ENTITLED: "A RESOLUTION AUTHORIZING THE MAYOR AND THE CITY CLERK TO SIGN A FINAL PLAT FOR BUFFALO RIDGE ESTATES, 11TH FILING, A REPLAT OF LOT 15, BLOCK 21, BUFFALO RIDGE ESTATES, CHEYENNE, LARAMIE COUNTY, WYOMING (LOCATED SOUTHEAST OF THE INTERSECTION OF HILLTOP AVENUE AND BLUFF PLACE)."

Buffalo Ridge Estates, 11th Filing **Expedited Preliminary Plat**

CASE NUMBER(s): UDC-20-00021

STAFF REPORT

Buffalo Ridge Estates, 6th Filing Preliminary Plat

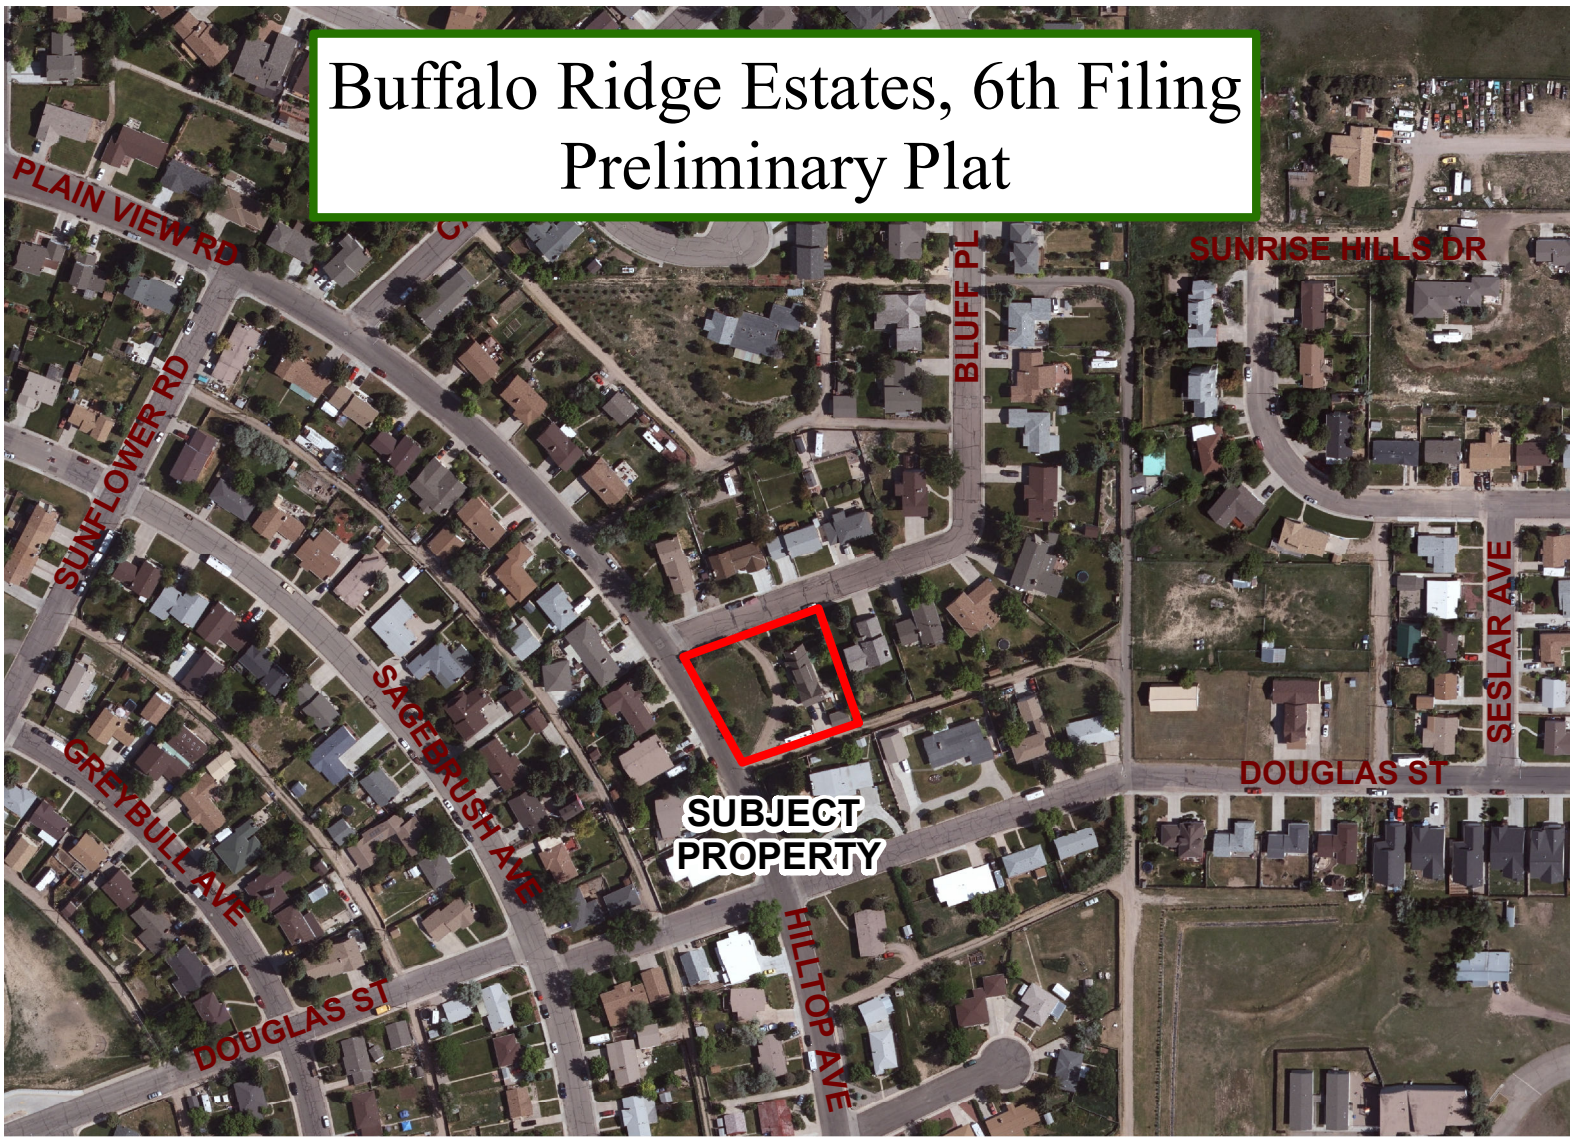
- o **(FYI)** Lots 2 & 3 could also be built as a duplex (SD1).
 - o **(Corrections made with revised map)** Technical Corrections:
 - "Buffalo Ridge Estates, Sixth Filing" was recorded in 1963. Please rename to "Buffalo Ridge Estates, 11th Filing"

- Please renumber "Block 40".
 - Please remove "1st Filing" wherever it appears (it was "Buffalo Ridge Estates", not "Buffalo Ridge Estates, 1st Filing").

ELEVENTH FILING

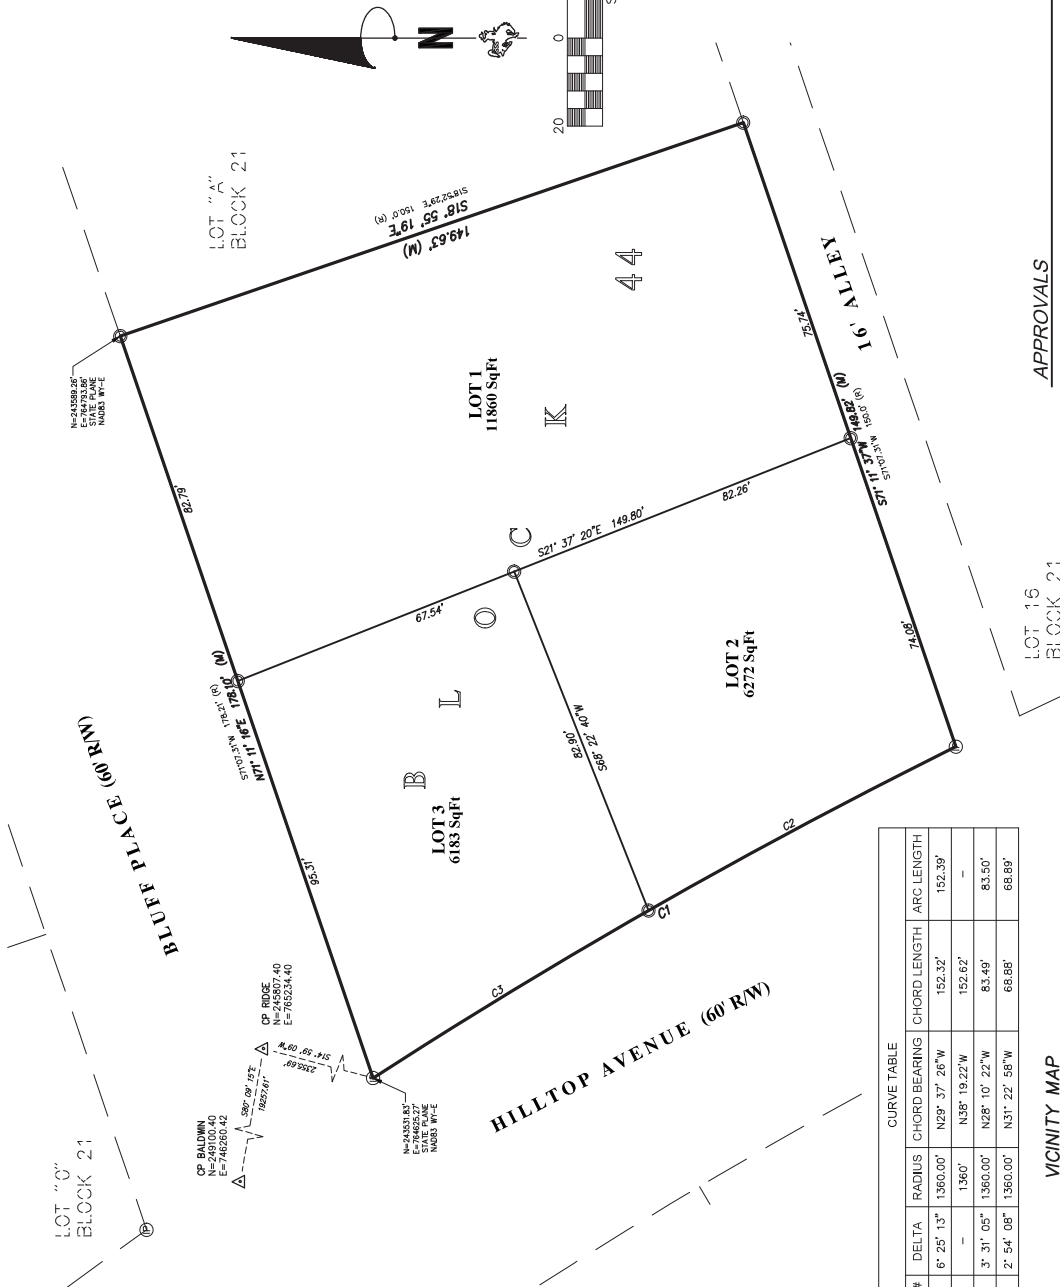
- Planning and Development (Seth Lloyd)
 - o **(FYI)** The plat appears eligible for expedited review.
 - o **(FYI)** Lot 1 is proposed as a DD5 lot. The proposed lot with existing structure meets area, frontage, setbacks, and coverage requirements. The existing structure is addressed off of Hilltop, and will need changed to be addressed off of Bluff Place with this subdivision.

- o **(FYI)** Lots 2 and 3 are proposed as DD7 lots. Note that the properties would be considered to front off of Hilltop; however, as Hilltop is a collector street, vehicle access will be required to be off of the alley or Bluff.

- Master Application; Preliminary Plat Map; Final Plat Map; Drainage Worksheet; Traffic Worksheet
- Revised Final Plat Map – submitted 1/27/2020 (submitted to make technical corrections)
